Children's Grief Center
Tenant Improvement
4125 Carlisle Blvd NE
Albuquerque, NM 87107

PERMIT SET

SITE PLAN AND
DETAILS

From: Phillips, Cory A. <cphillips@cabq.gov>
Sent: Wednesday, May 19, 2021 4:51 PM
To: R. Jarrod Cline
Subject: RE: 4125 Carlisle TCL (permit # BP-2021-16177)

B1 SITE PLAN
1" = 20'-0"

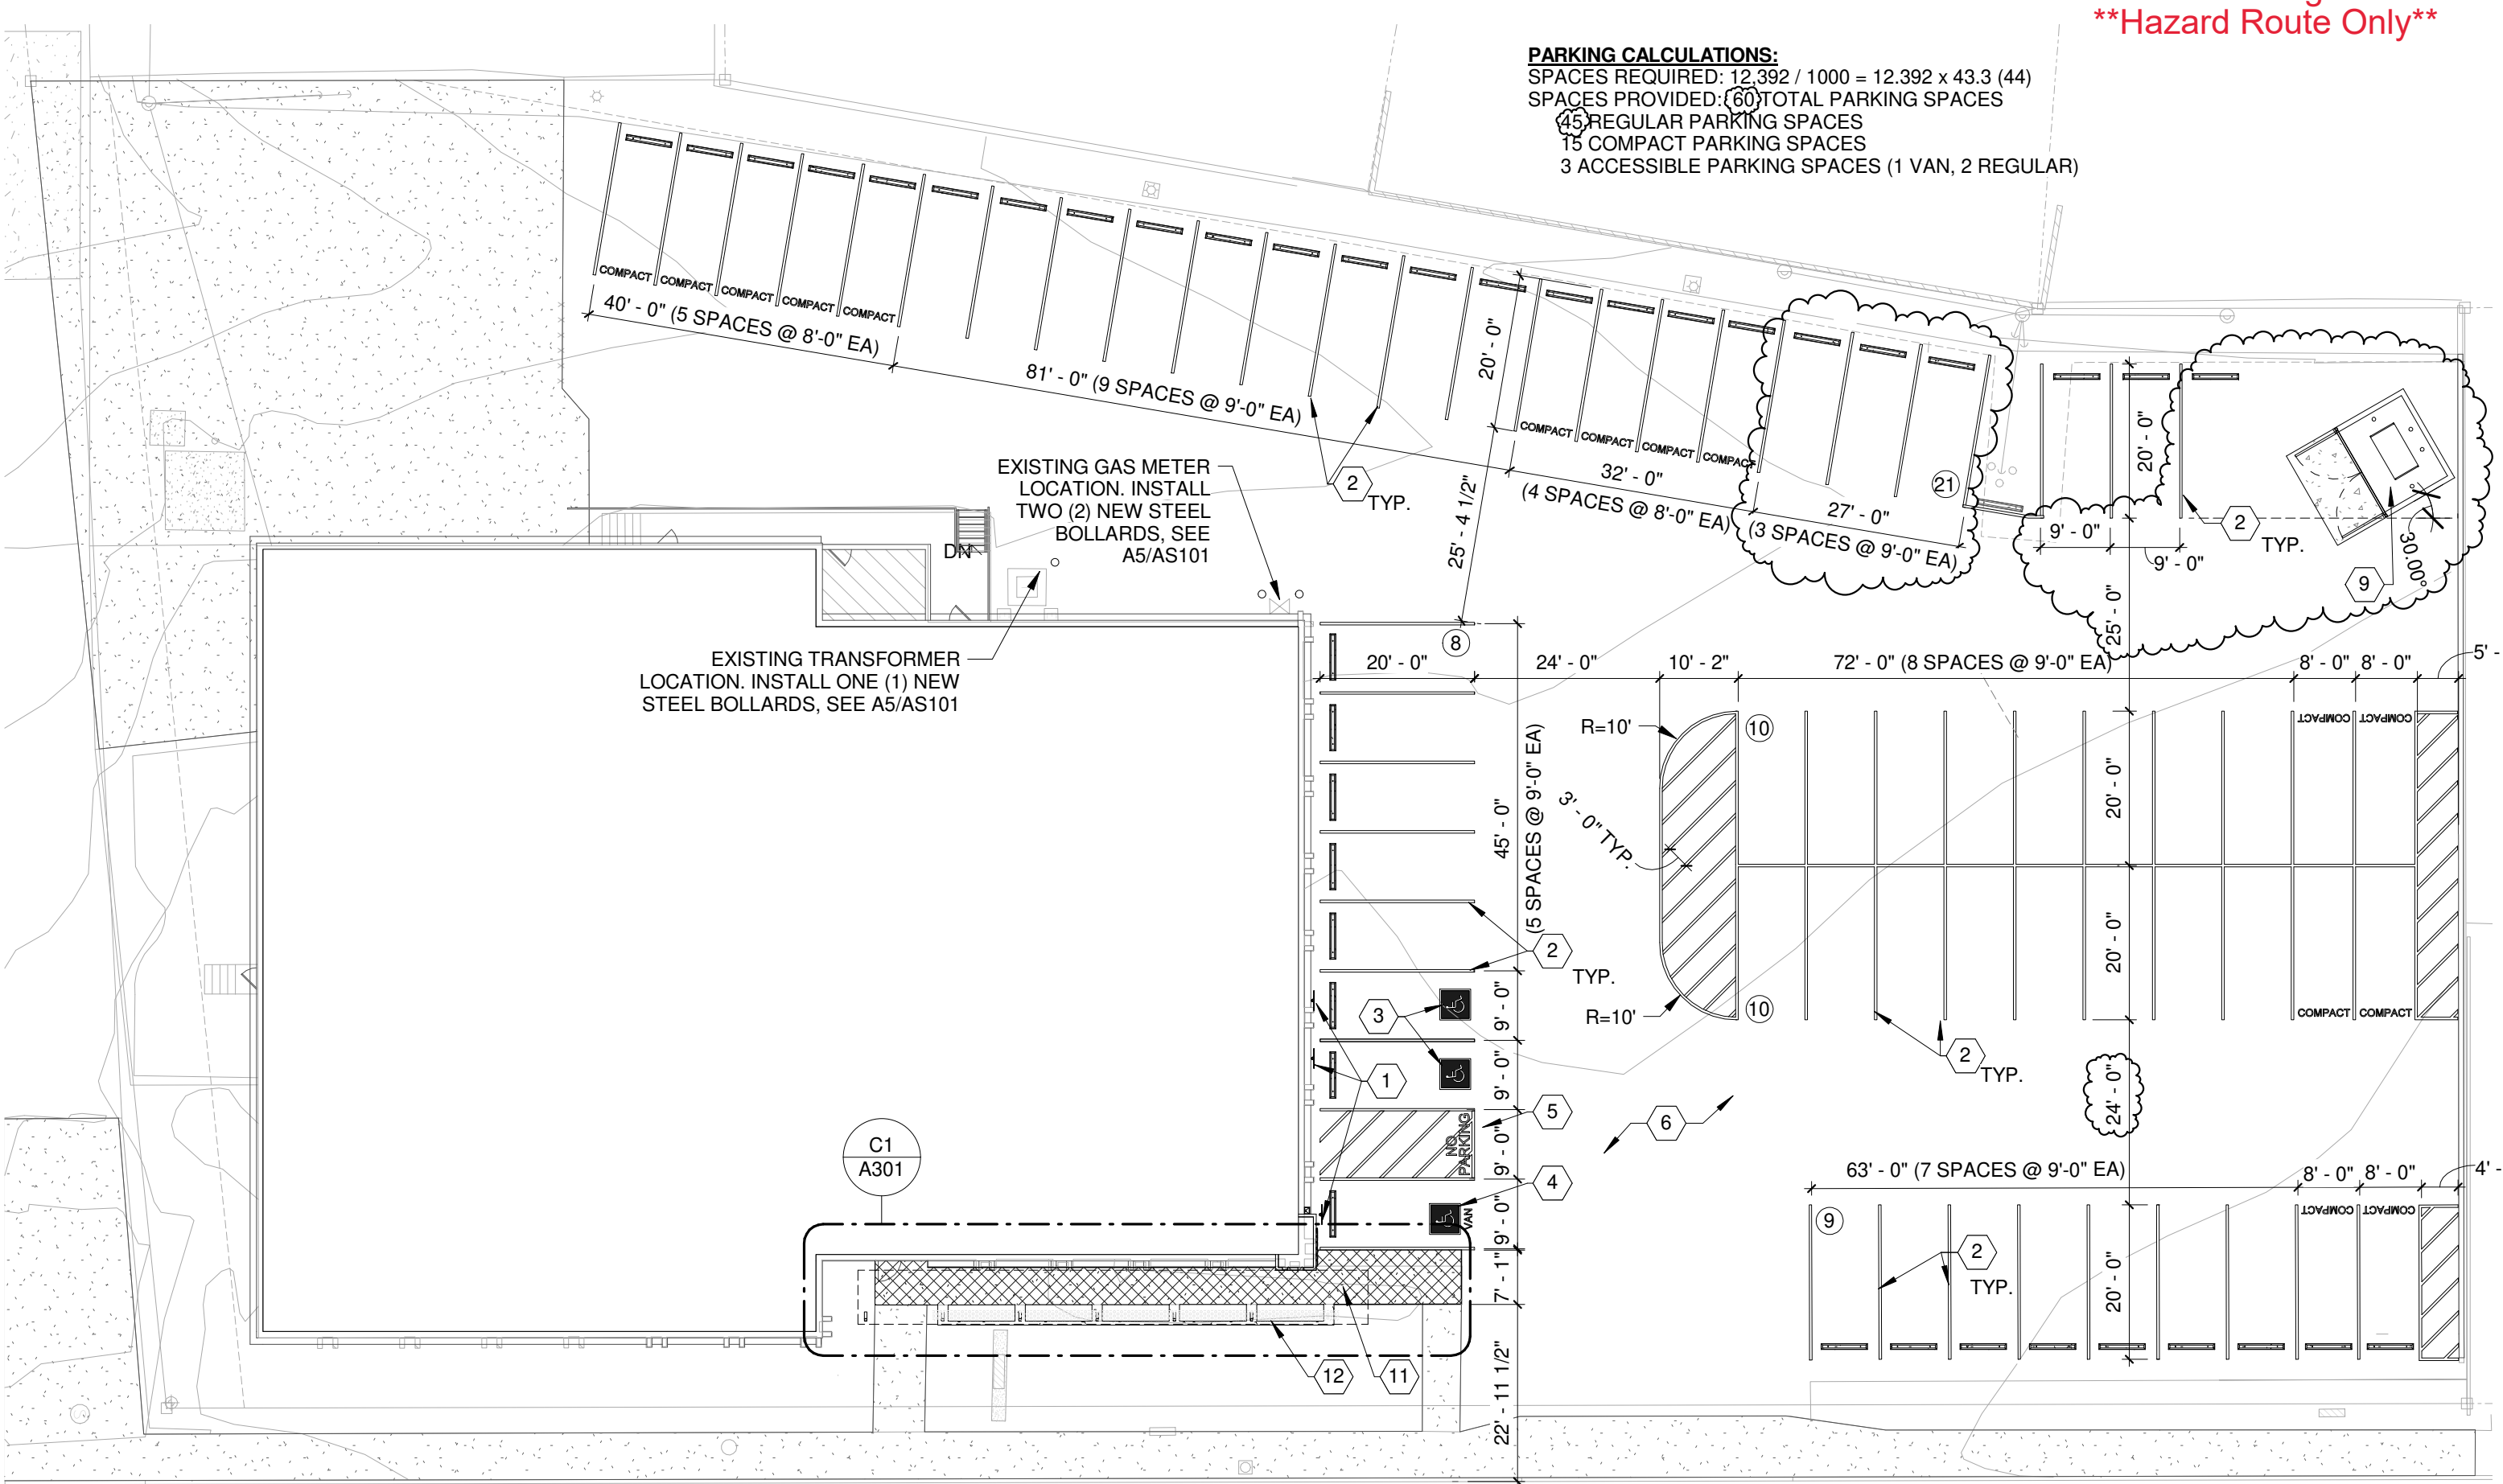
Jarrold, I was able to do a quick review of the site plan for 4125 Carlisle and as long as the parking improvement plan does not affect the access of emergency vehicles which it does not appear to be the case then fire does not have any issues moving forward. This email is conditional only to the current parking improvement project. If any additional square footage or plans change this approval would be void and a fire 1 would be required. If you have any further questions or concerns feel free to contact the office.

Good afternoon Cory. Attached is the TCL letter I received requesting Fire approval for the changed layout at 4125 Carlisle Blvd. I've attached the latest TCL site drawing that shows the existing parking lot striping (lower left) and a plan with the new striping. Please take a look and let me know if you have questions, my cell number is below. Thanks
jarrod
